RE: Notice of Application for The Woods at Viewcrest

**From:** Deborah Wessell <wessell@live.com>  
**Sent:** Wednesday, May 29, 2024 3:57 PM  
**To:** Bell, Kathy M.; Sundin, Steven C.; Lyon, Blake G.  
**Subject:** Please require an EIS for the Proposed Subdivision on Mud Bay Cliffs

# Appendix 1: The Woods at Viewcrest: Building Envelope & Existing CAO Areas (Site Plan Sheet 5)

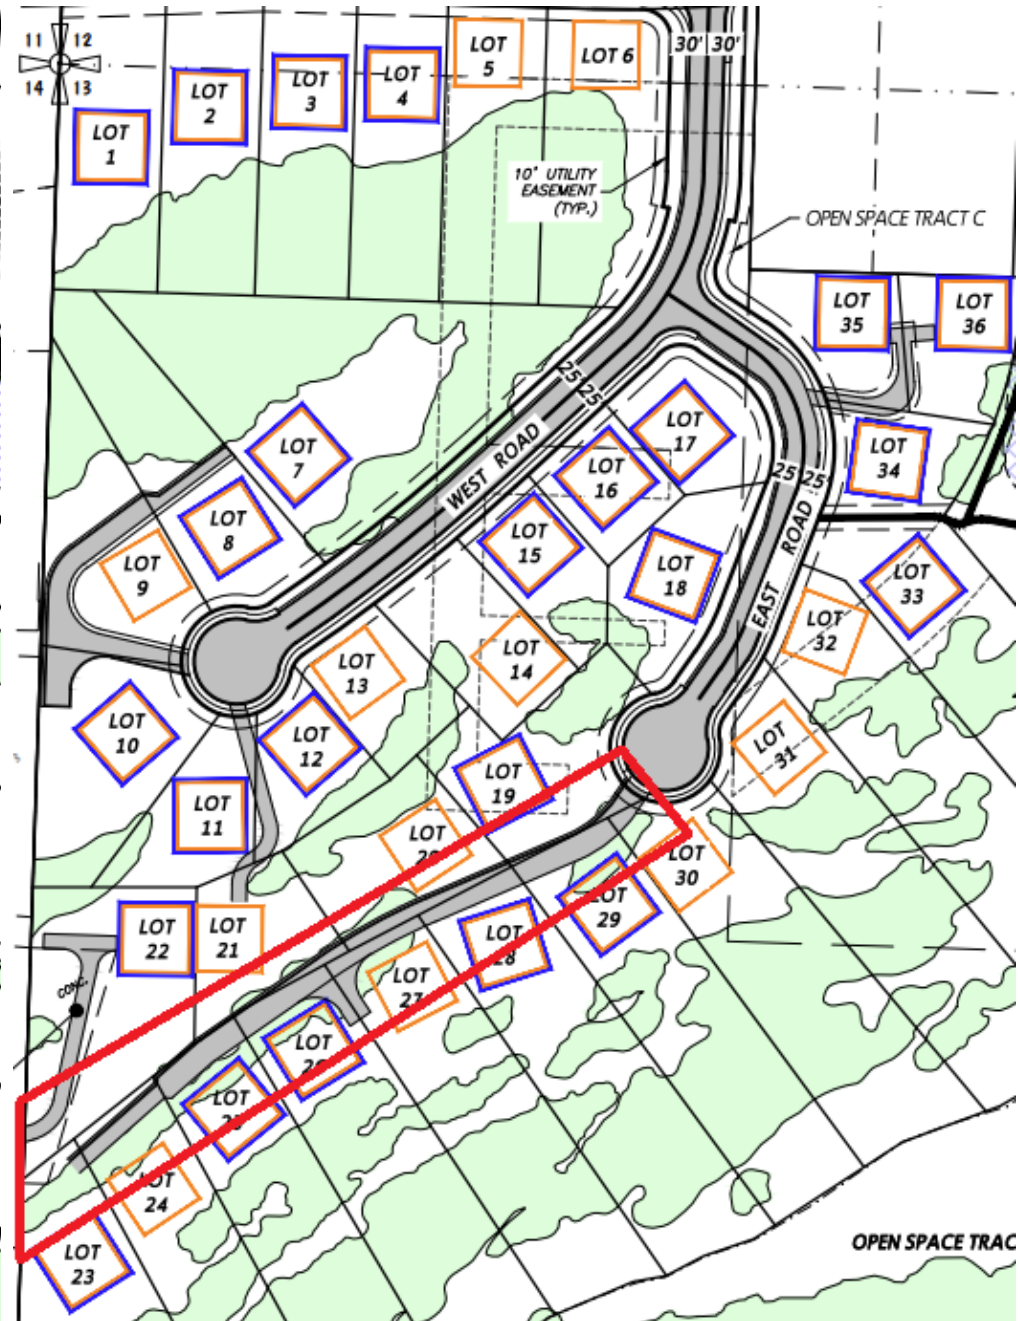
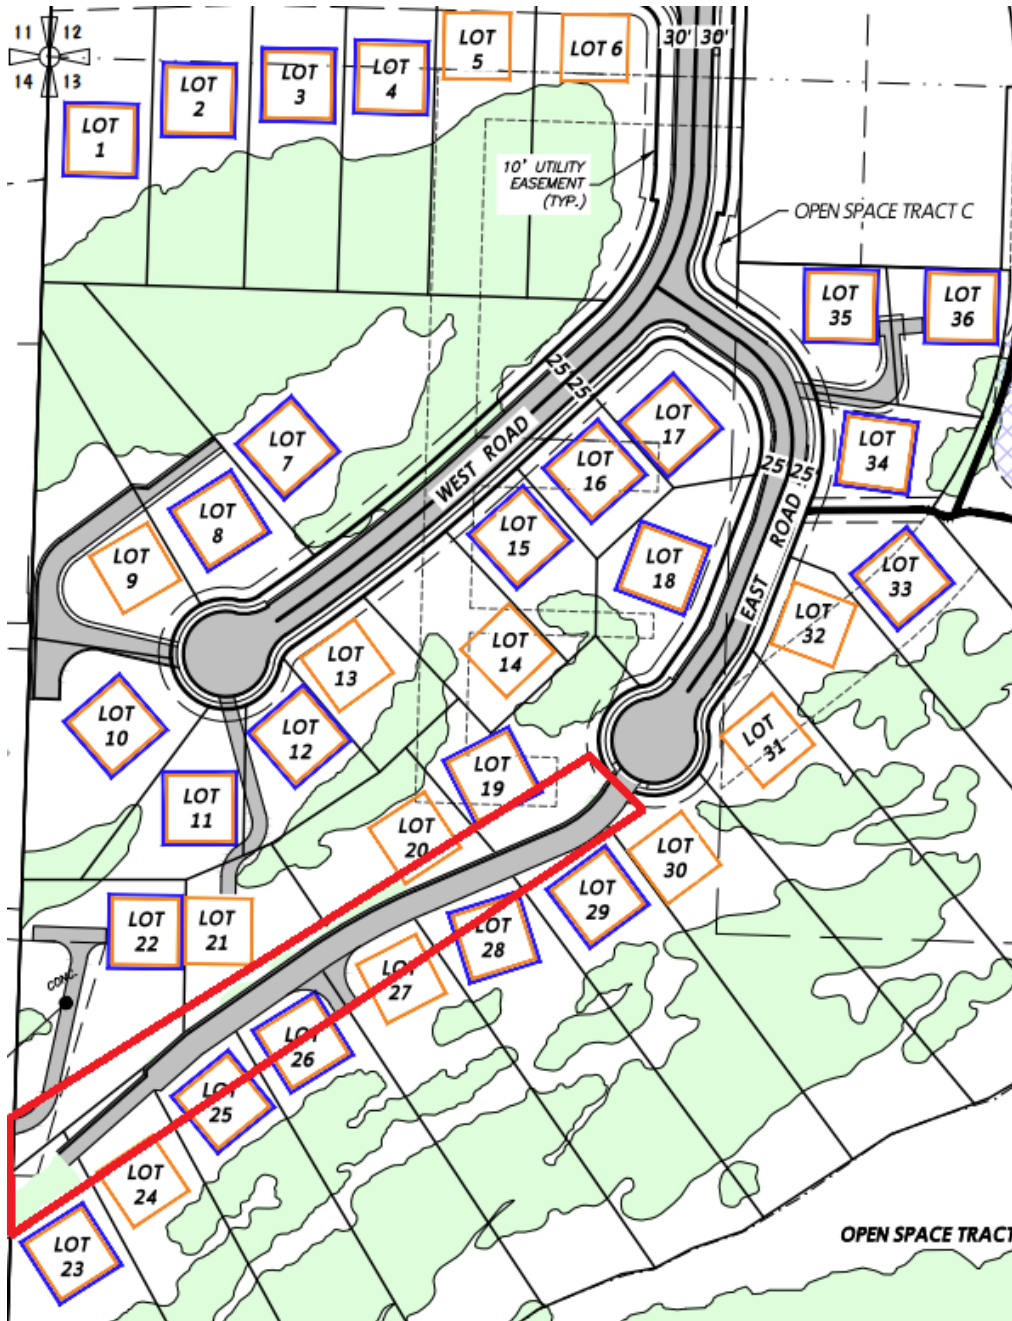
- In a desperate attempt to prove that the building envelopes are not encumbered by geologically hazardous areas, the applicant has, without any explanation, deleted a large section of GEOLOGICALLY SIGNIFICANT CRITICAL AREAS impacting lots 20, 23-27, and 29-30. These GEOLOGICALLY SIGNIFICANT CRITICAL AREAS are depicted by green polygons on the 6/9/23 Building Envelope & Existing CAO Areas site plan but not on the updated 12/1/23 version of this site plan. In other words, these green polygons were purposely deleted from the 6/9/23 version when the 12/1/23 version was prepared. These site plans are presented as Sheet 5 in their respective set of project plans (applicant Exhibit A). The impacted area is shown in the red boxes in Appendix 1 below. This deletion represents either an intentional misrepresentation of existing critical areas or an egregious error that raises serious questions about the reliability of the applicant’s project plans.

- The green GEOLOGICALLY SIGNIFICANT CRITICAL AREA polygons on the 12/1/23 Building Envelope & Existing CAO Areas site plan (applicant Exhibit A, Project Plans, Sheet 5) fail to include many of the site’s erosion and landslide hazard areas that are illustrated in yellow and orange on the applicant’s 10/6/22 *Percent Slope Map* (Figure 3B of the Geotech Report at Exhibit E). This significant omission impacts lots 4-5, 11-13, 16-17, 22-31, 33-34 and 36. The impacted area is shown in the red boxes in Appendix 2 below. The failure to disclose these erosion and landslide hazards areas also represents either an intentional misrepresentation of existing critical areas or an egregious error that raises serious questions about the reliability of the applicant’s project plans.

# Appendix 2: The Woods at Viewcrest: Building Envelope & Existing CAO Areas (Site Plan Sheet 5)

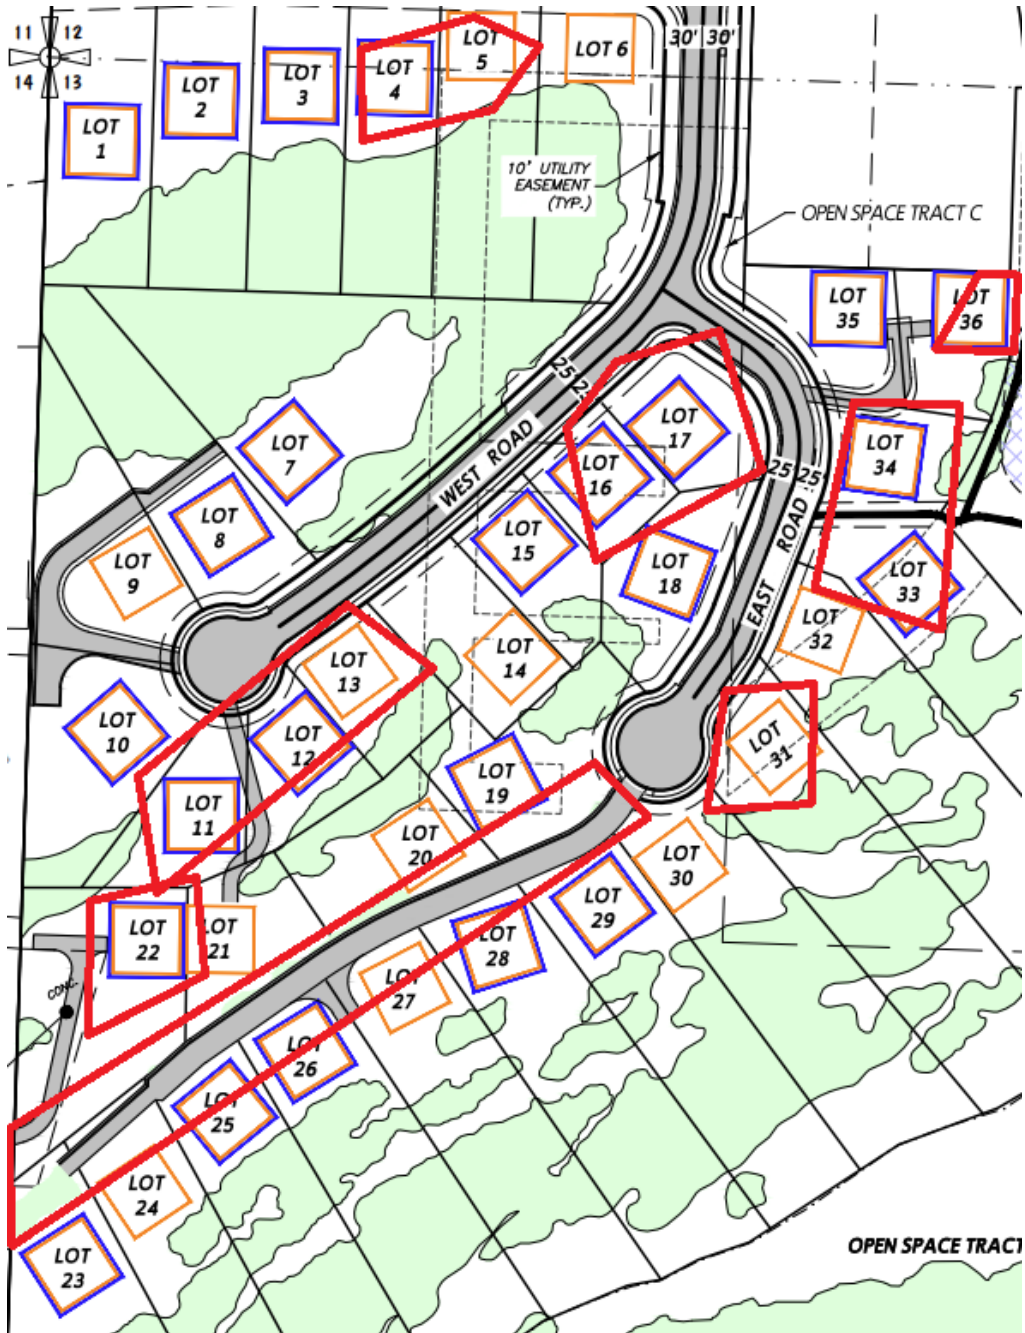
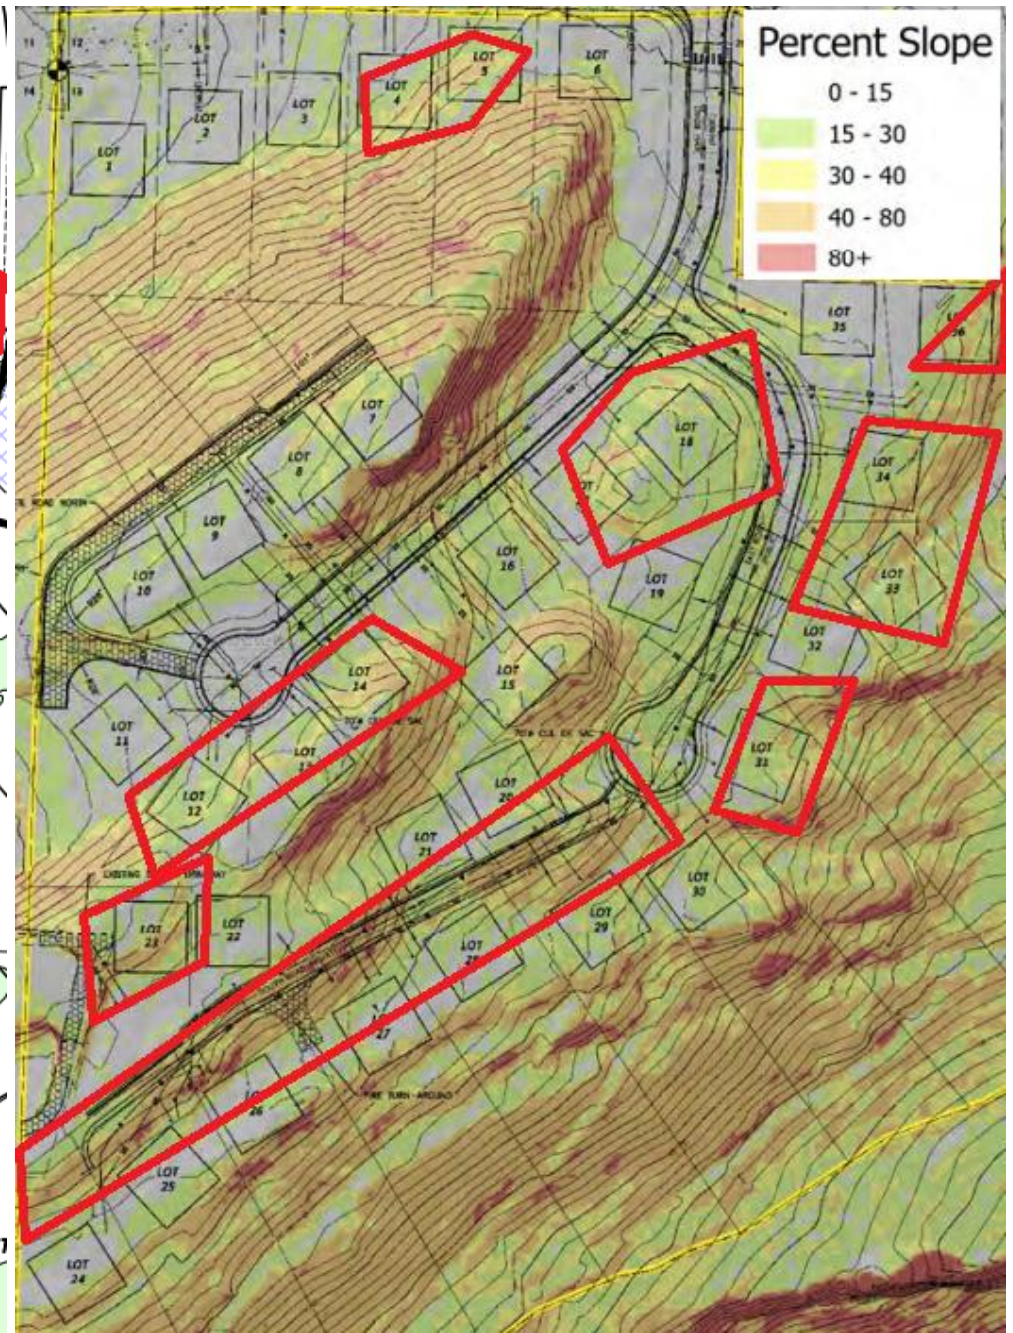
- As explained in Exhibit A of the *Protect Mud Bay Cliffs* public comment submittal (<https://bit.ly/PMBC-EXH-A>, page 14, item C.18 *Outdated Plans and Maps*), the *Project Area & Lot Layout* and the *Percent Slope Map & Lot Layout* presented in the applicant's 10/6/22 [Geotechnical Investigation & Geohazard Report](#) (applicant Exhibit E, Figures 2 and 3B) are outdated and do not reflect changes made to the project plans. Consequently, references to specific lots within the applicant's geotech report (e.g., §4.4.2, §5.1.3, §5.12.1) are internally inconsistent with the actual project plans and lot configurations presented in the applicant's Exhibit A. The use of outdated information, combined with internal inconsistencies, cause the 10/6/22 geotech report to be unreliable.

## Failure to Disclose Erosion & Landslide Hazard Areas
